PETERSBURG, ALASKA
PETERSBURG JAMES A. JOHNSON AIRPORT
EAST APRON EXPANSION
PROJECT NO. 68283 / AIP 03-02-0219-0903

| SHEET NO. | DESCRIPTION |
|--------------------------------|--|
| AS-BUILT PLANS | |
| 10/28/03 - 10/1/04 | |

STRIPING & TIE-DOWN PLAN

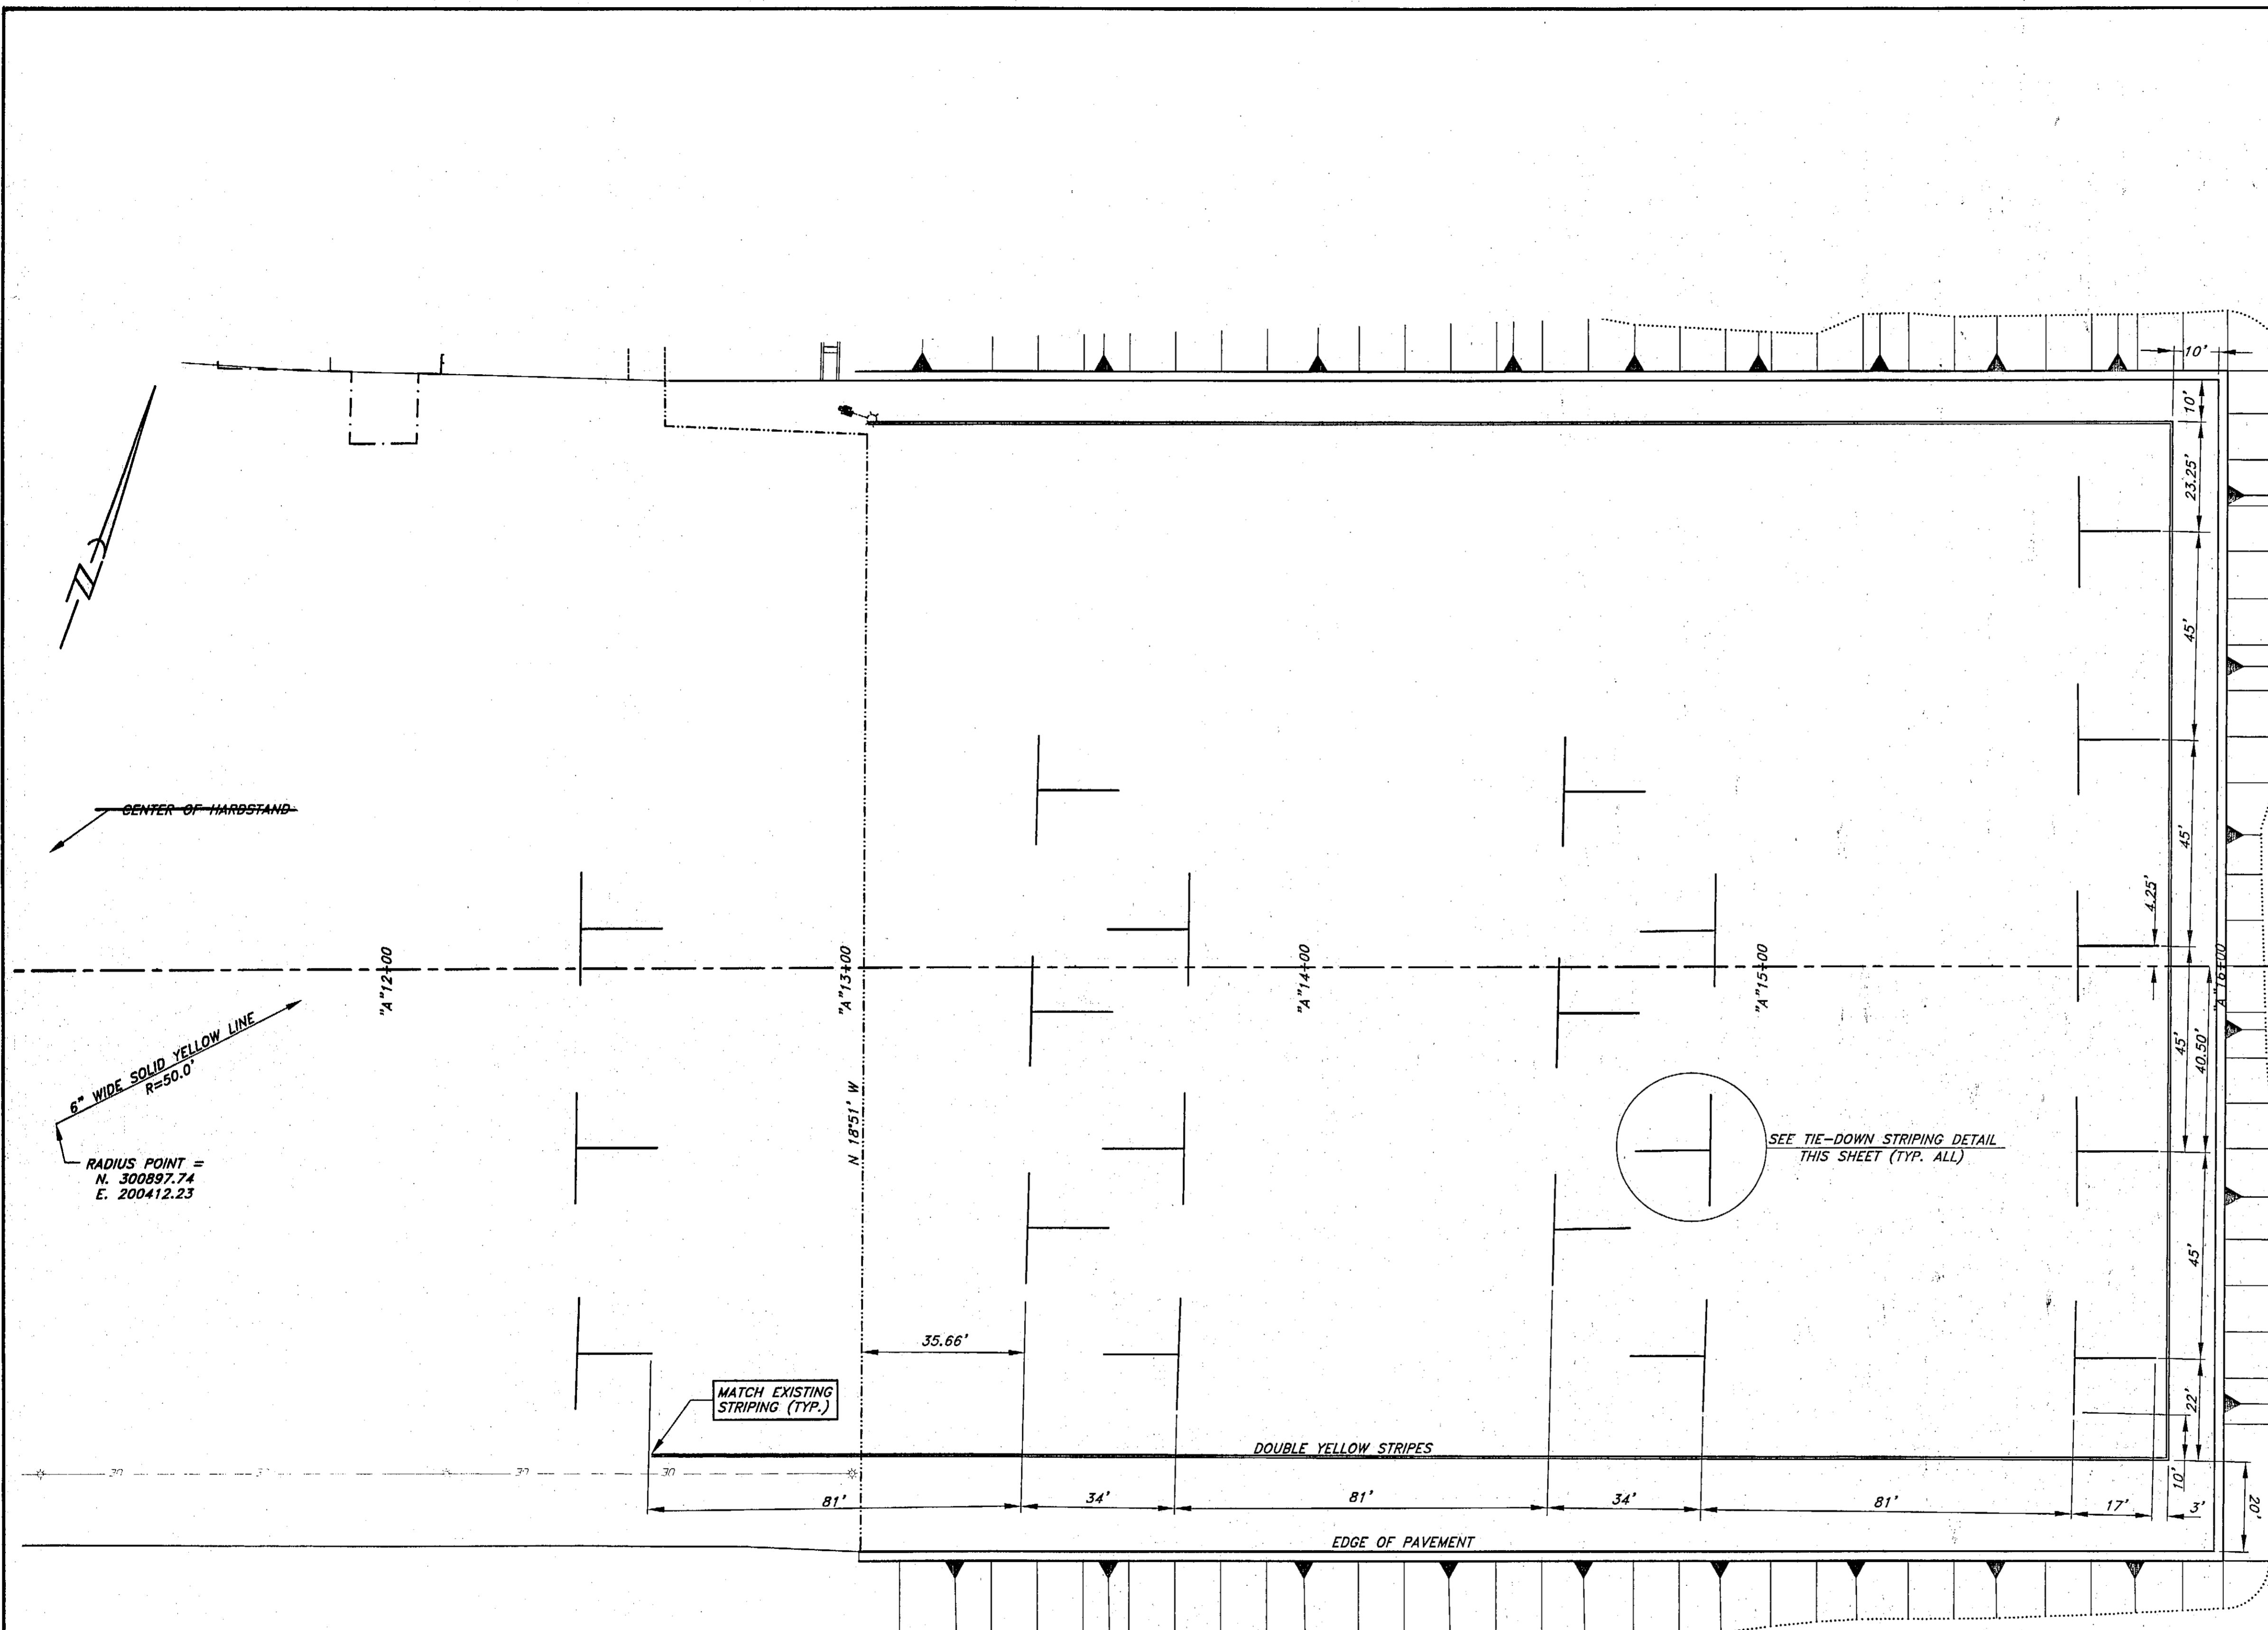
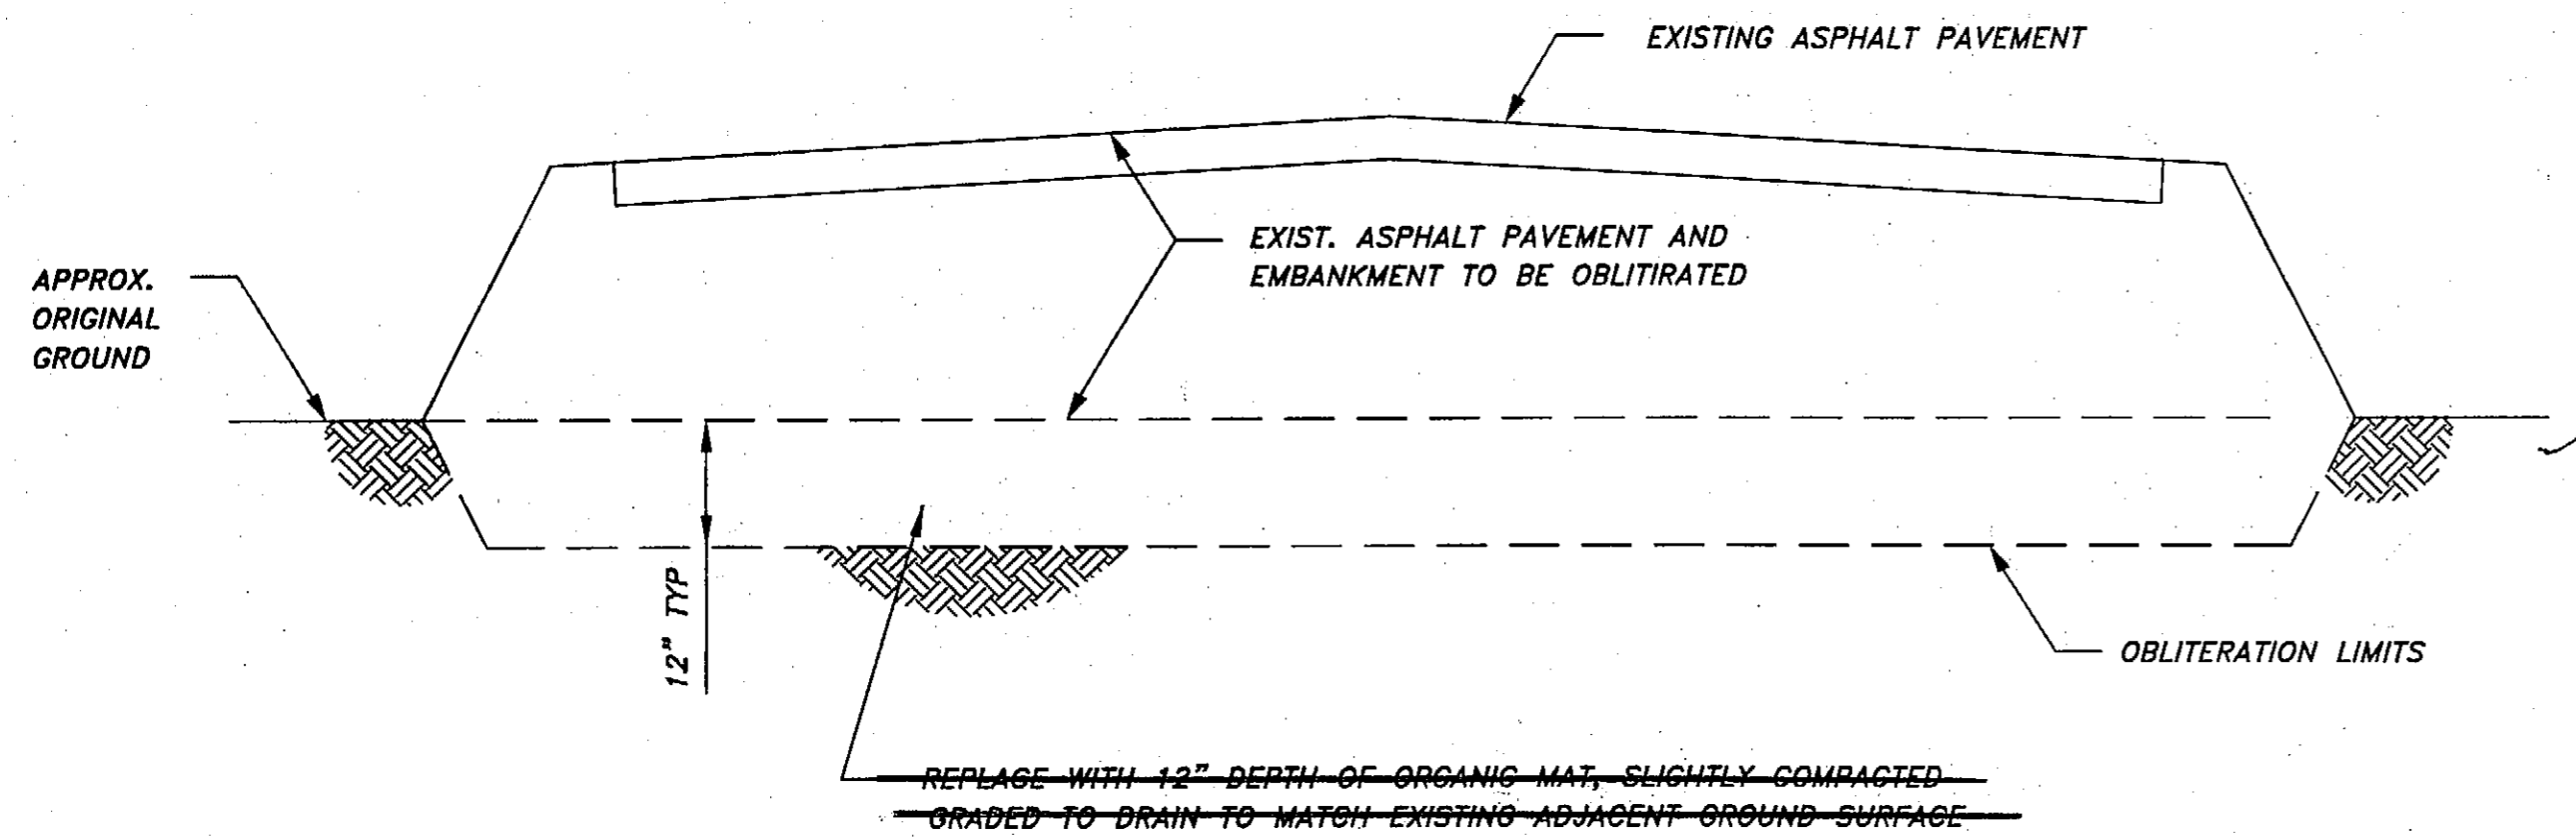
CHANGE ORDER #3 - ESTABLISHES ITEM P. 6200 - TIEDOWN STRIPING REMOVAL

PETERSBURG
 PETERSBURG JAMES A. JOHNSON AIRPORT
 EAST APRON EXPANSION
 ELECTRICAL SITE PLAN

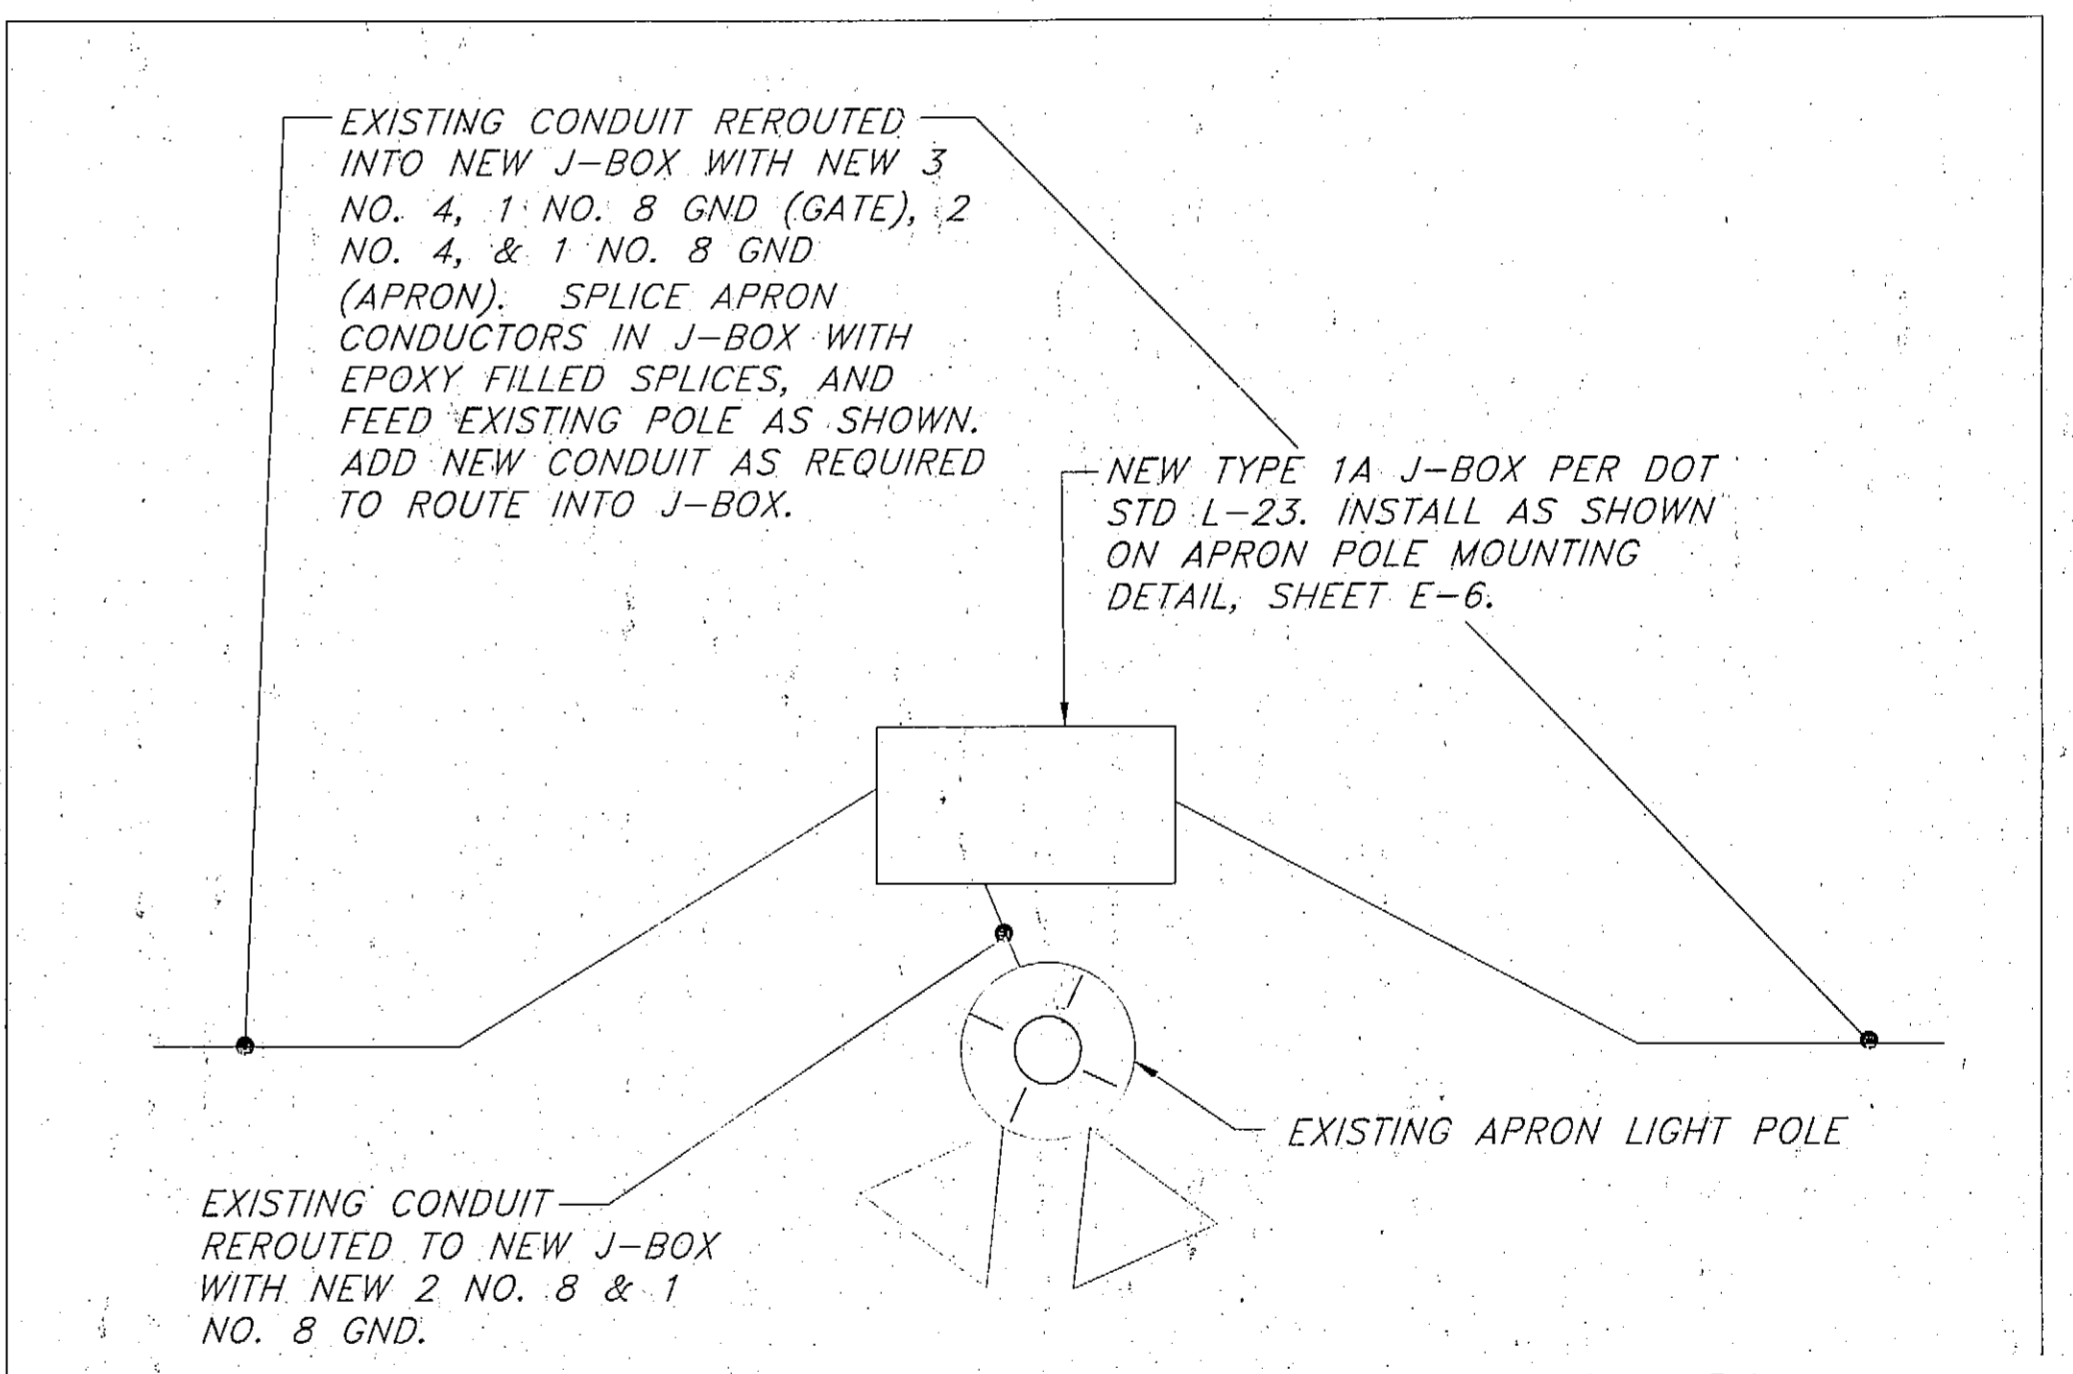
- ~~THE EXISTING APRON LIGHTS ARE TO REMAIN. THEY ARE FED BY A FEEDER IN CONDUIT THAT IS ROUTED FROM PANEL A TO HAND HOLE H2 THEN THROUGH HAND HOLES H4, H6, AND H8 TO THE FIRST FLOOD LIGHT. THE FEEDER IS THEN ROUTED IN CONDUIT BETWEEN LIGHT POLES. RE-USE THE EXISTING CONDUIT AND REPLACE THE FEEDER CONDUCTORS WITH 2 NO. 4 AND 1 NO. 8 GND (APRON LTS) AND 3 NO. 4 AND 1 NO. 8 GND (GATE). REPLACE THE APRON FEEDERS ACROSS THE APRON TO ALL EXISTING APRON FLOOD LIGHTS. FEED THE NEW FLOOD LIGHT ON THE NEW APRON FROM THE LAST EXISTING FLOOD LIGHT. SEE SHEET E-2.~~

- ADD TYPE 1A J-BOX AT EACH EXISTING APRON LIGHT POLE. INTERCEPT THE EXISTING CONDUITS THAT FEED THE POLE, AND RE-ROUTE THEM INTO THE NEW J-BOX. ROUTE THE NEW (3) NO. 4 AND 1 NO. 8 GND (GATE) THROUGH THE J-BOX. SPLICE THE NEW, 2 NO. 4 AND 1 NO. 8 GND (APRON) TO NEW 2 NO. 8 AND 1 NO. 8 GND CONDUCTORS AND RE-FEED THE EXISTING POLE WITH THE 2 NO. 8 AND 1 NO. 8 GND. SEE DETAIL THIS SHEET.
